## Pre-Pour Concrete Slab Report

Inspection Date: 25 Mar 2020

Property Address: Greenvale Area, Vic

## Non Compliant 2.04

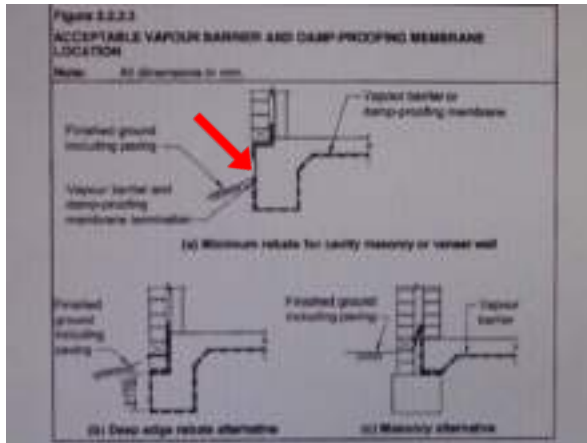
Finding: polyethylene vapour barrier not installed as per BCA - Part 3.2.2.6  
Defective Vapour Barrier Installation - Damaged/Punctured and/or overlapping Defective.

It was noted at the time of inspection that a vapour barrier had not be installed in accordance with AS2870 and BCA Part 3.2.2.6.

Whilst the majority of the vapour barrier system has been done correctly there are minor areas of non compliance to repair.

- 1/ All over laps are not taped as described below.
- 2/ All the rips and/or damaged area needs to be taped.
- 3/ Some areas are not up to future ground and/or finished paving or concrete heights and must be extended with 200mm overlay and taped.
- 4/ Somes areas whilst listed above are Damaged / Ripped / Not Consistent And Sealed with 200mm Overlay And Taped / Not High Enough / Non Existent must ALL be repaired.

The polyethylene vapour barrier from beneath the concrete floor slab must be turned up the external side faces of its edge beams. Failing to install the vapour barrier correctly will allow moisture ingress via slab edge dampness into the internal timber wall skins and/or the floor coverings if not done.

The polyethylene vapour barrier must properly extended up the external side faces of the edge beams to at least the height of future finished ground level or paving i.e. 75mm below the damp-proof course and bottoms of the weepholes, after which any termite barriers that are in place, if required, will also need to be properly instated.

## Non Compliant 2.05

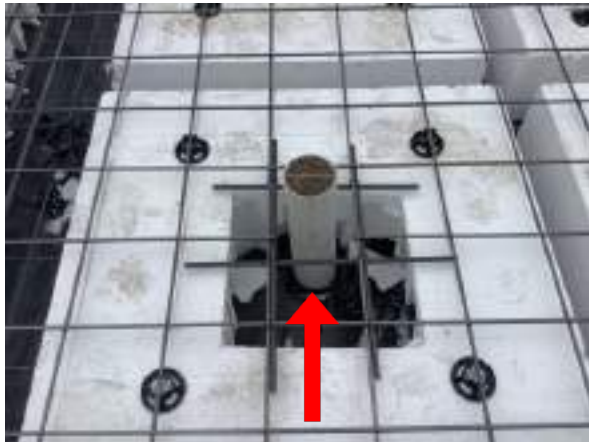
Finding: Pipe penetrations through the vapour barrier.  
The pipe penetrations through the vapour barrier have not been fully taped and require further works.  
There are also numerous cuts and tears throughout the vapour barrier that have not been taped correctly.  
These will need to be taped up and photographed before the pour is started.

## Non Compliant 2.06

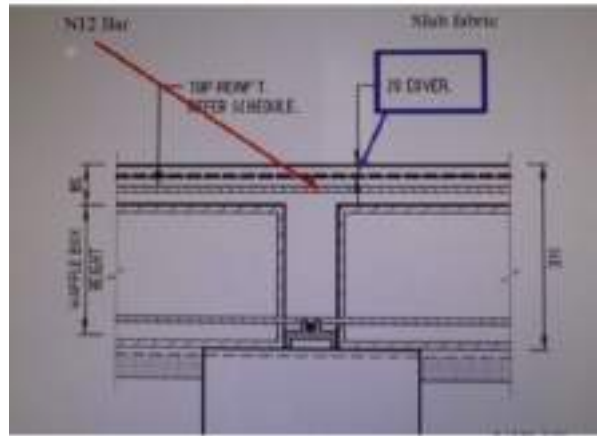
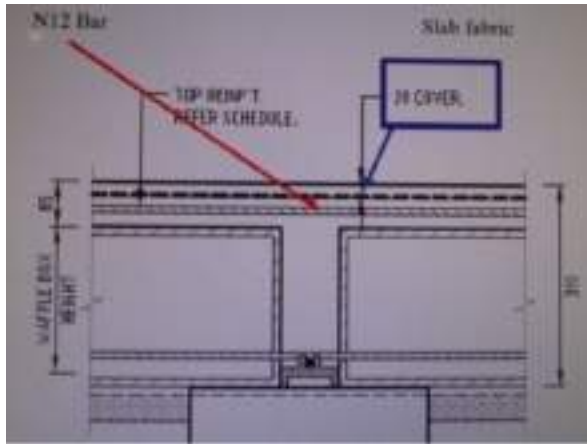
Finding: Defective Earthing To Steel Mesh.

The earthing facility installed to the dwellings slab steel as required in AS 3000 Requires additional wire tie.

I refer the builder to AS 3000, clause 5.6.2.5 that states "Any conductive reinforcing within a concrete floor or wall forming part of a shower or bathroom shall be bonded to the earthing system".
